## ADDENDUM # 1

Project: HVAC Replacement of 237-255 Essex Street, Lawrence MA

TBA Project: 1268.1

Date: September 16, 2016

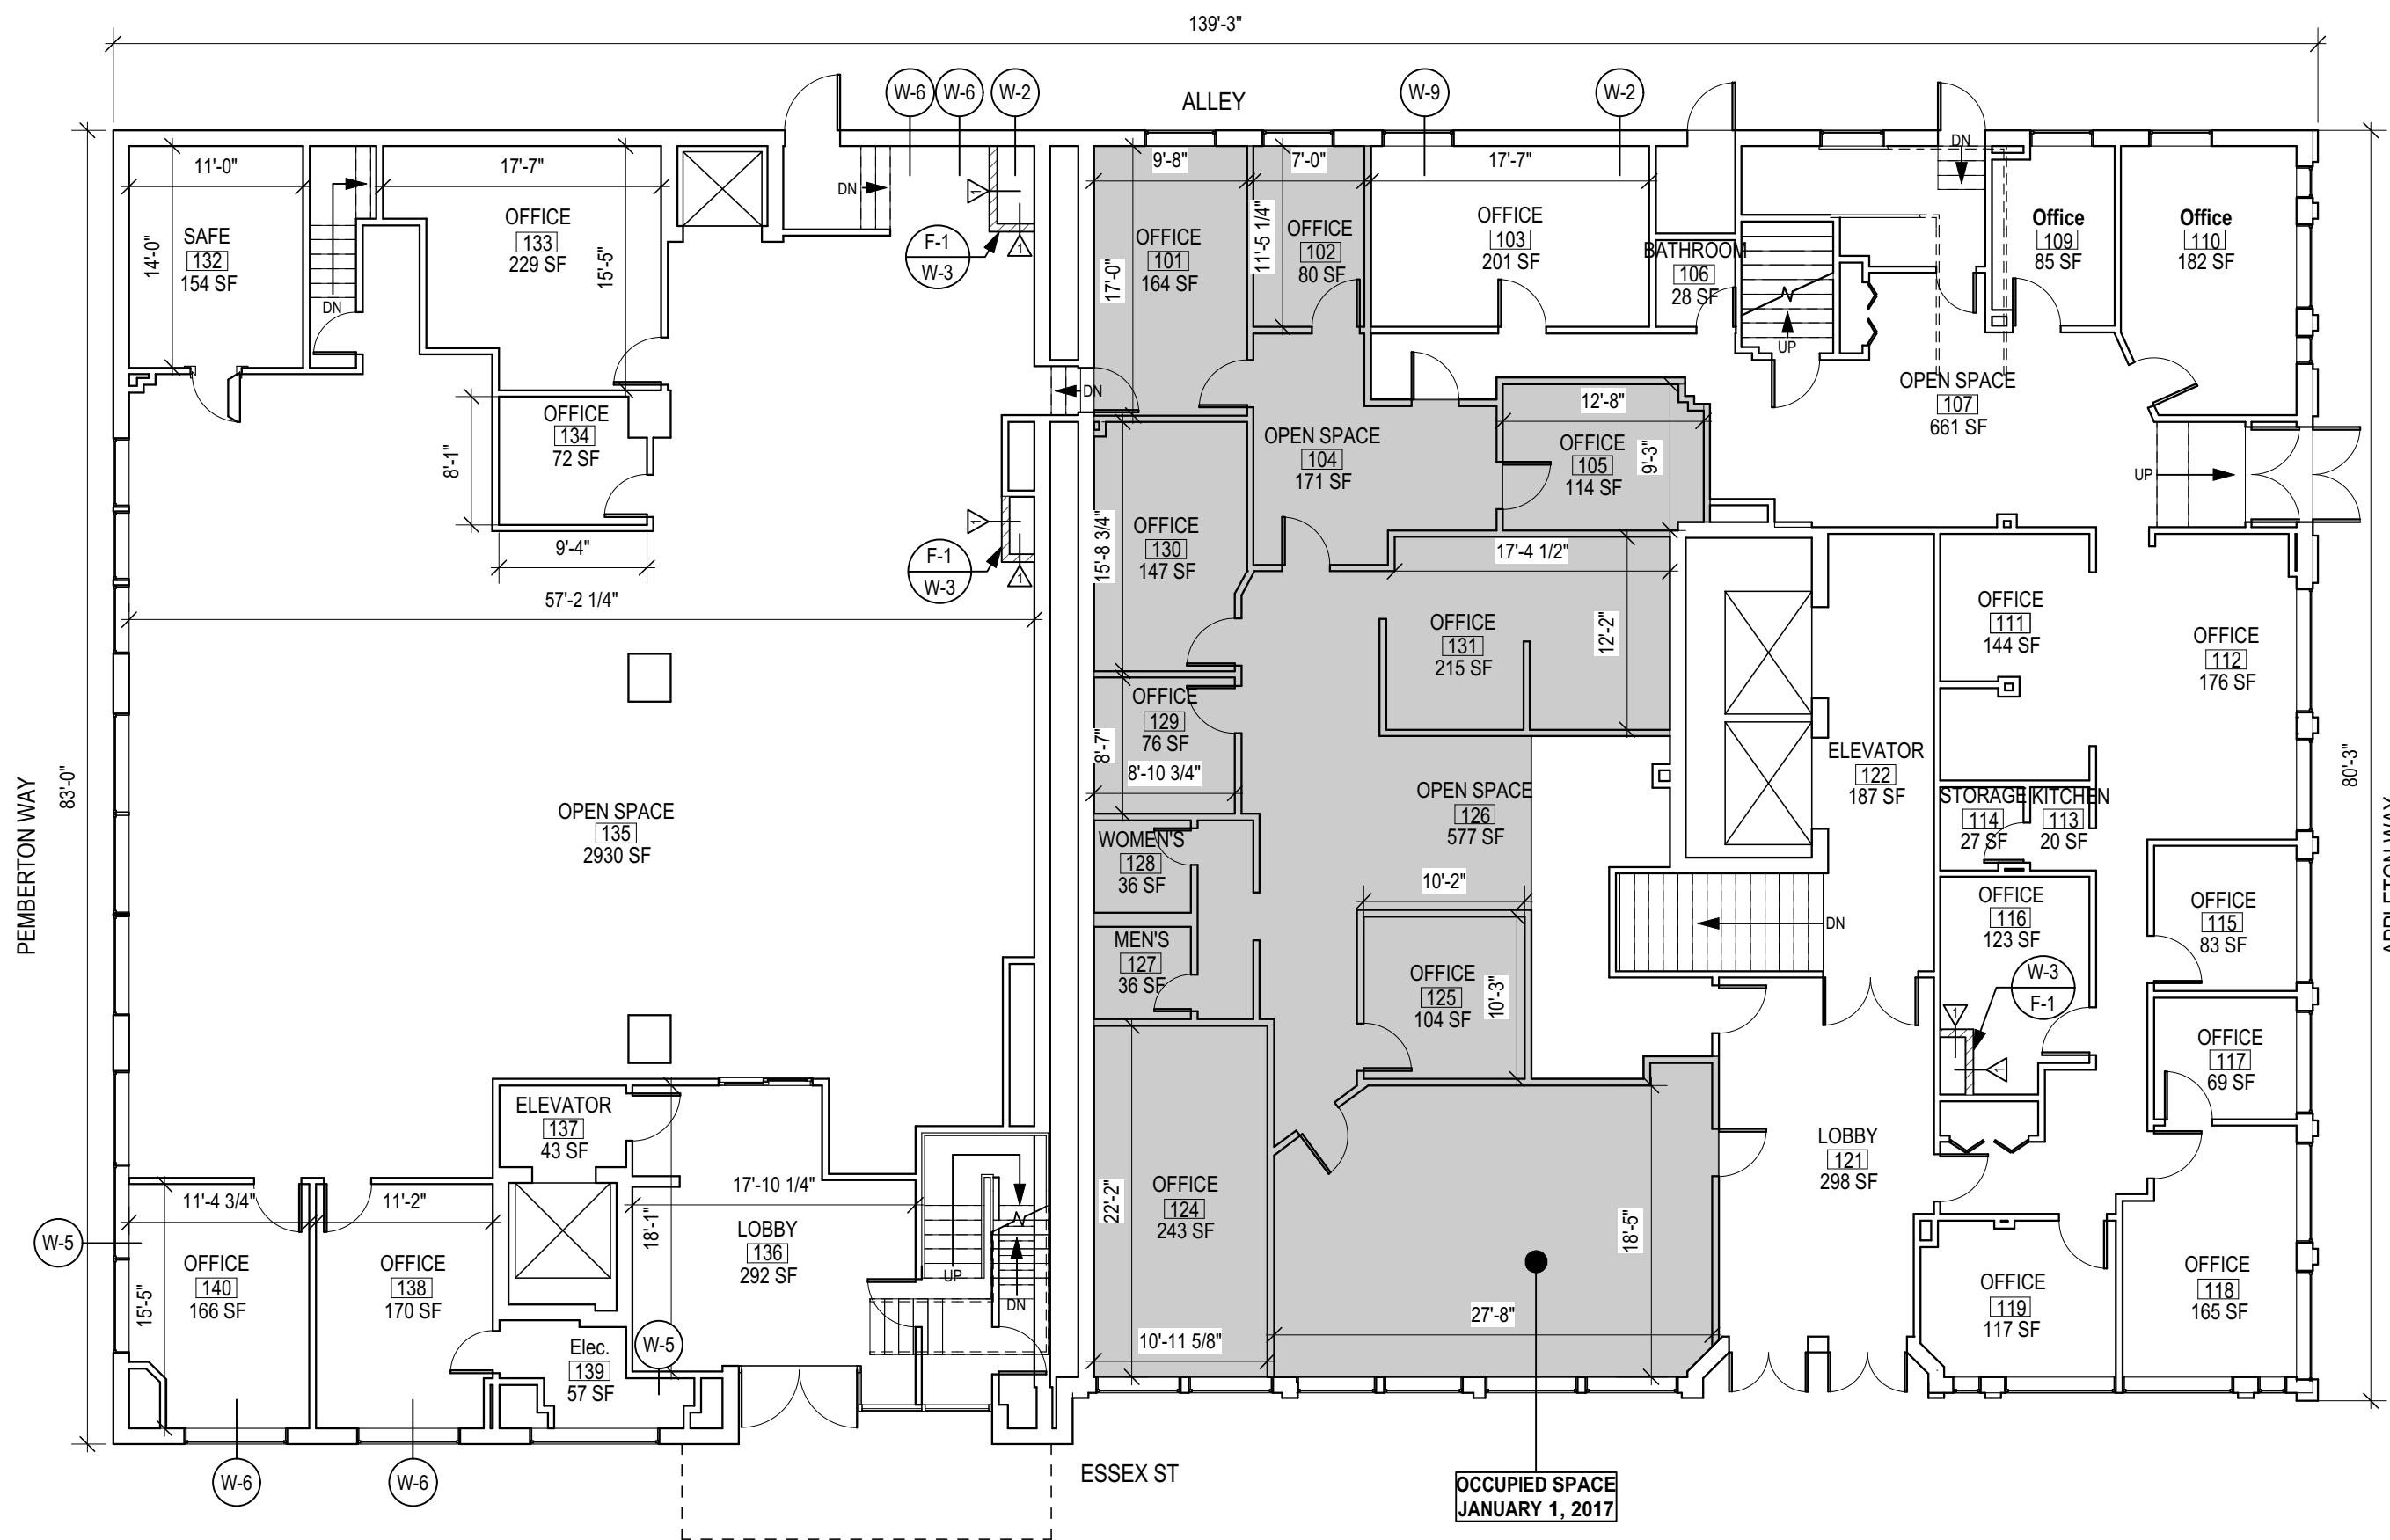
Q What area of the buildings is required to be occupied by January 1, 2017?

Q Can we use the elevator at the back of 255 Essex to access the basement level?

A The elevator has been decommissioned. (It is shown on the attached SK-1.0 between Office #133 and a door to the Alley at the top of the drawing.) The hoistway goes from the basement to the second floor only and has been sealed by the elevator maintenance company. The City does not intend to reactivate the elevator and would consider this use should you wish to employ the hoistway by opening the doors and lawfully removing and disposing of the equipment so long as the hoistway would be fully and permanently sealed and interior finishes completed by January 1.

A Floors 1 through 4 of 255 Essex Street and a portion of the first floor of 237 Essex Street are to be occupied by January 1. The specific area of 237 Essex Street is indicated in the attached drawing, SK-1.0 (one page). All partitions dividing the space from the remainder of the first floor of 237 Essex Street will be constructed by the city. The basement areas of both 237 and 255 Essex will NOT be occupied space.
